PIPELINE SAFETY & RELIABILITY PROJECT (PSRP) (A.15-09-013)

(DATA REQUEST ORA-66)

Date Requested: January 19, 2017 Date Responded: February 16, 2017

RESPONSE 7:

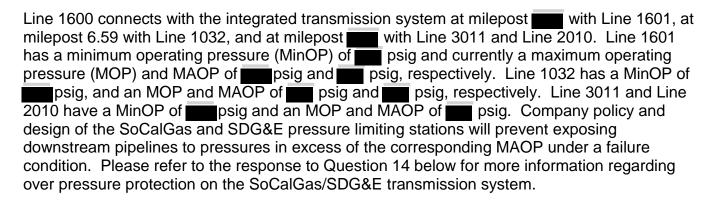
Please provide a listing of the interconnection points Line 1600 would have with transmission pipelines south of Rainbow Station. For each interconnection point provide:

- a. The name and designation of the interconnecting line;
- b. The maximum allowable operating pressure (MAOP) of the interconnecting line;
- c. The maximum and minimum operating pressure of the interconnecting line;
- d. At each interconnection point, what pressure and for how far Line 1600 would experience that pressure if the pressure limiting valve at the interconnection point failed.
- e. The milepost on Line 1600 of each interconnecting line.

This response contains confidential information (shaded in gray) and is provided pursuant to Cal. Pub. Util. Code § 583, General Order 66-C and D.16-08-024. Accordingly, a confidentiality declaration is included with this submission.
